Title of Change:	Final Change Notification for changes to tape and reel pitch and quantity per reel for WLCS devices (case outlines: 567VS, 567JZ, 567XK)
Proposed First Ship date:	03 Sep 2021 or earlier if approved by customer
Contact Information:	Contact your local ON Semiconductor Sales Office or Marek.Haluska@onsemi.com
PCN Samples Contact:	Contact your local ON Semiconductor Sales Office or PCN.samples@onsemi.com . Sample requests are to be submitted no later than 30 days from the date of first notification, Initial PCN or Final PCN, for this change. Samples delivery timing will be subject to request date, sample quantity and special customer packing/label requirements.
Additional Reliability Data:	Contact your local ON Semiconductor Sales Office or Tomas.Vajter@onsemi.com
Type of Notification:	This is a Final Product/Process Change Notification (FPCN) sent to customers. FPCNs are issued 90 days prior to implementation of the change. ON Semiconductor will consider this change accepted, unless an inquiry is made in writing within 30 days of delivery of this notice. To do so, contact PCN.Support@onsemi.com

Final Product/Process Change Notification

Document #:FPCN23605XA

Issue

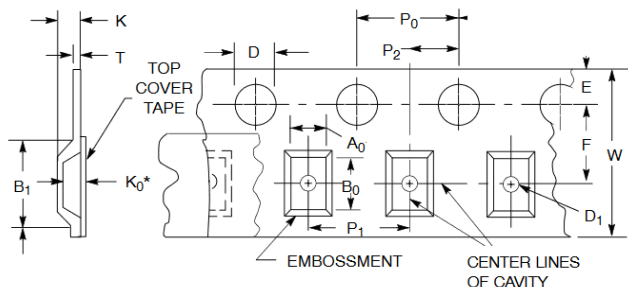
- Case outlines: **567VS, 567JZ, 567XK:**
 - Tape and reel pitch will be changed from 4mm pitch to 2mm pitch.
 - Quantity per reel will be changed from 5,000 units to 10,000 units.

Dimension P1 (refer to below picture) will be changed from 4mm to 2mm.

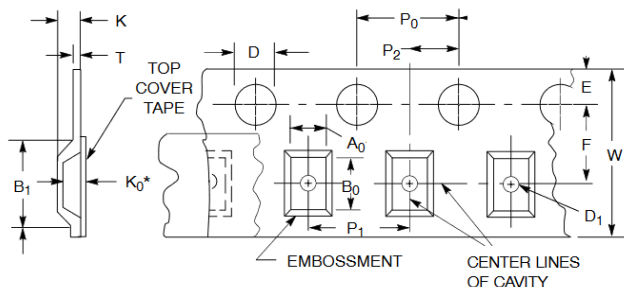
- テープ&リールのピッチが 4 mm ピッチから 2 mm ピッチに変更予定です。
- リールあたりの数量は 5,000 ユニットから 10,000 ユニットに変更予定です。

寸法 P1 (以下の図を参照) が 4 mm から 2 mm に変更予定です。
